EPA-AA-TEB-511-82-15

**EPA Evaluation of the Fuel Economizer Device Under  
Section 511 of the Motor Vehicle Information and Cost Savings Act**

**September 1982**

**Test and Evaluation Branch  
Emission Control Technology Division  
Office of Mobile Sources  
U.S. Environmental Protection Agency**

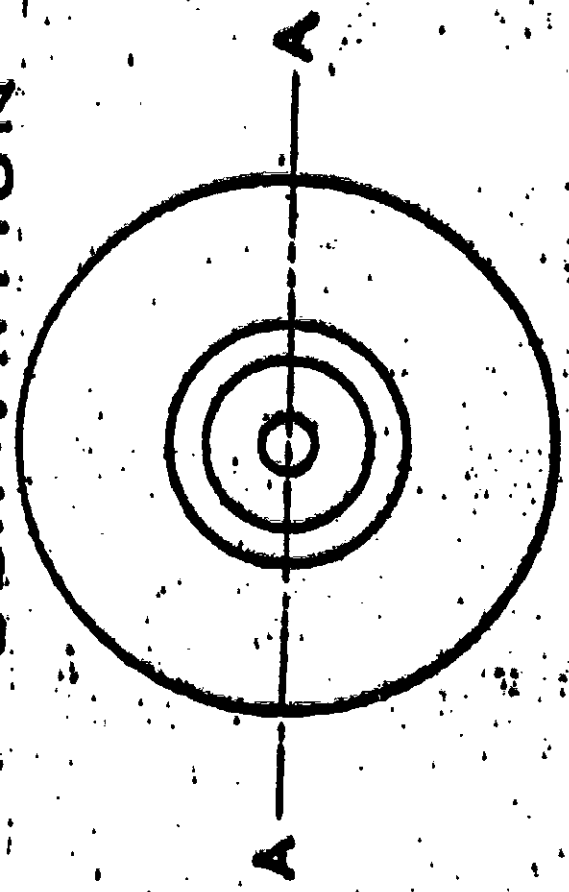
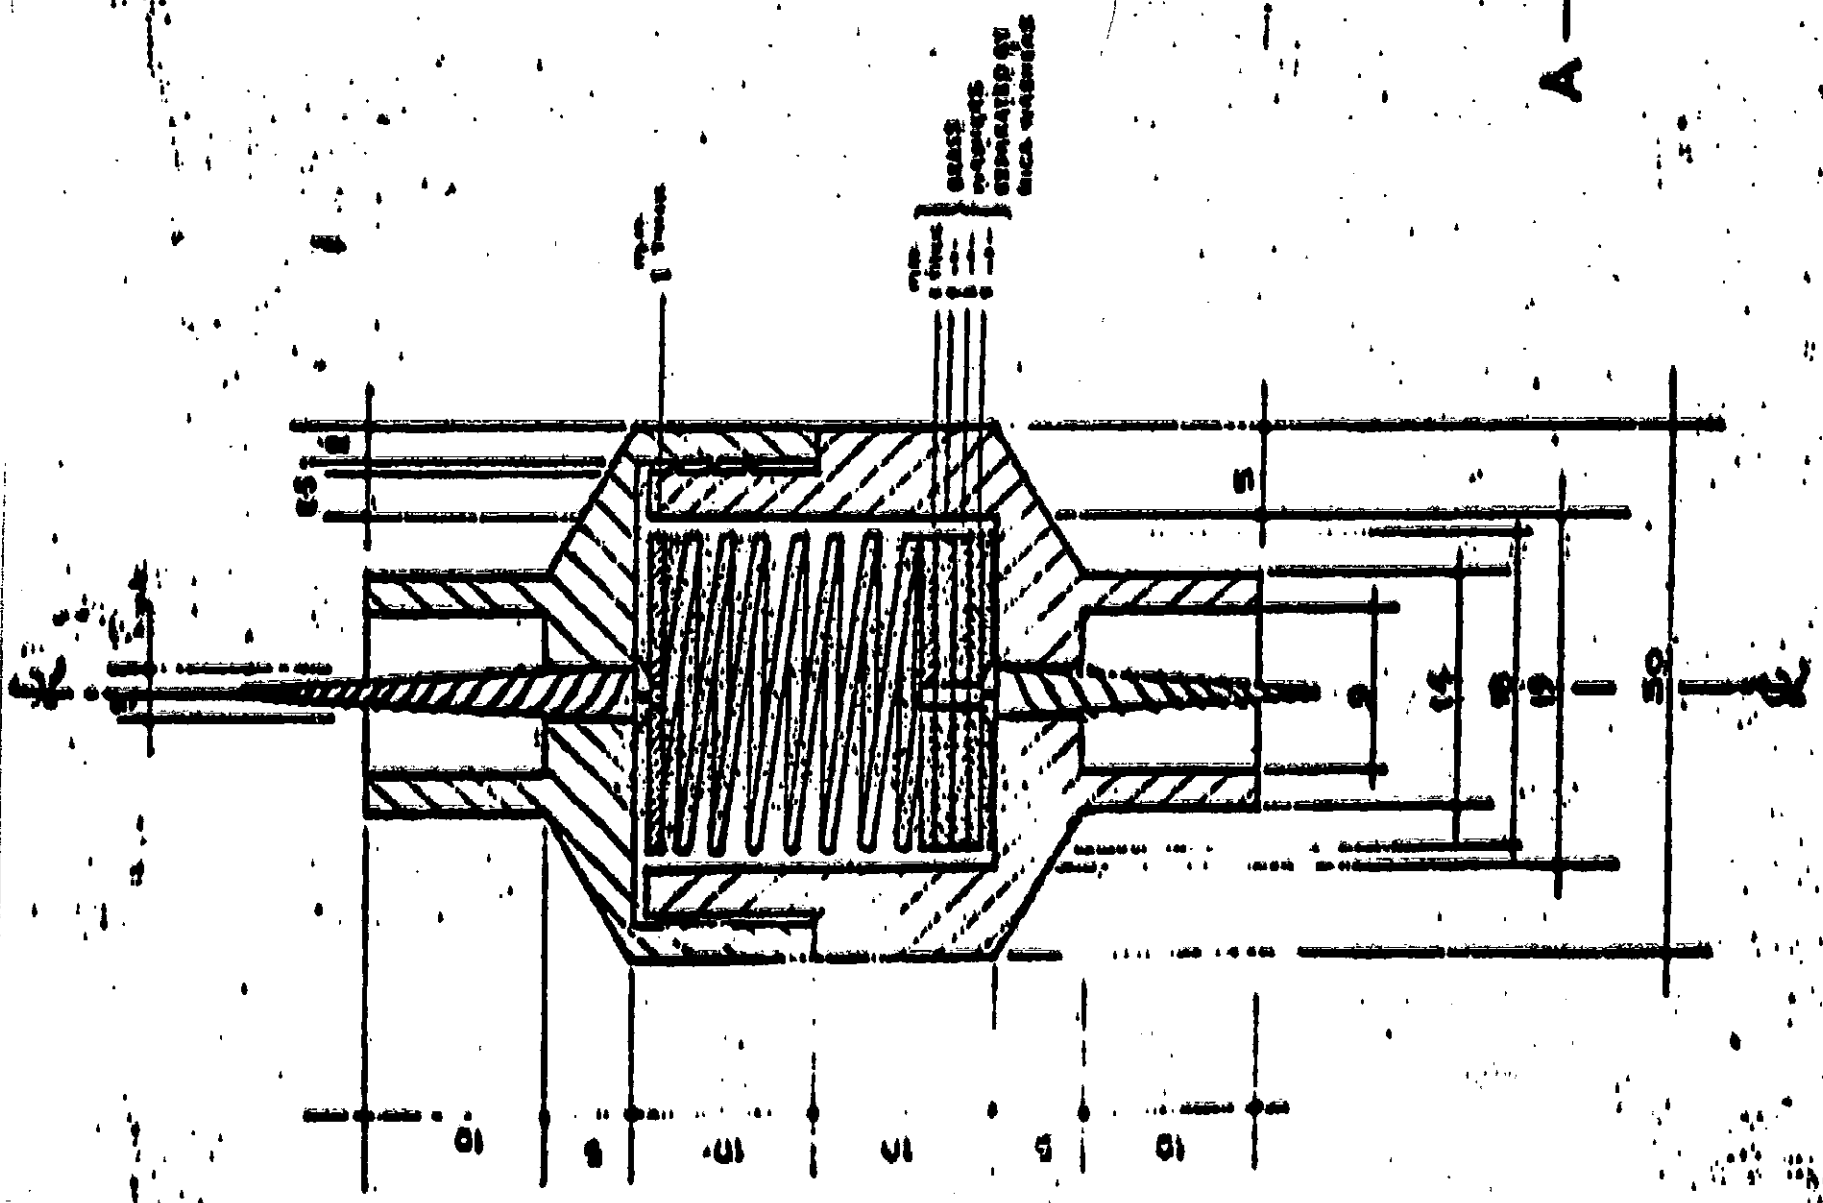
- (3) The description of the device given in the application was determined by EPA to not be adequate. The construction and operation were not discussed and the schematics of the device in Section 3(c) of the application were not detailed enough. EPA requested (Attachment B) additional details on the device. The applicant's response (Attachment A) included a narrative description and a schematic of the device. While these were considered helpful toward gaining a better understanding of the device, EPA was still not sure how the device functions without additional information from the applicant. The applicant was requested (Attachment C) to submit additional information, but none was provided.

3. Section 3(b) of your application describes the theory of operation for the device. Your description does not sufficiently detail how the device manages to convert secondary direct current to alternating current with a frequency of 20,000 cycles per second. Does the device consist of capacitors, resistors, transformers, or diodes? If so, what are their specifications? Considering that all spark ignition engines possess, even without your device, secondary alternating current of approximately 30 megacycles once the spark is established at the spark plugs (often referred to as the capacitance component of the spark discharge), the 20,000 cycles per second frequency attributable to your device would seem to have an insignificant effect when compared to that obtained from the 30 megacycle frequency. Please submit any additional information you may have showing the affect your device has on secondary resistance, capacitance, rise time, spark duration and available voltage. Also, provide a schematic drawing and a sectioned view of the device.

EPA para 2: For better understanding how the device functions, we would like to give the construction details. It consists of four brass discs on one side separated by mica insulator discs and one brass disc on the other side. These sub assemblies are held apart by metallic spring which also acts as a conductor of electric current. The brass end plates on both sides are directly in contact with the terminals housed in the melamine housing. We are pleased to enclose a sectional drawing showing the construction. There is no capacitor, resistor, transformer or diode. The simplicity of the construction makes the device fail proof and completely reliable.
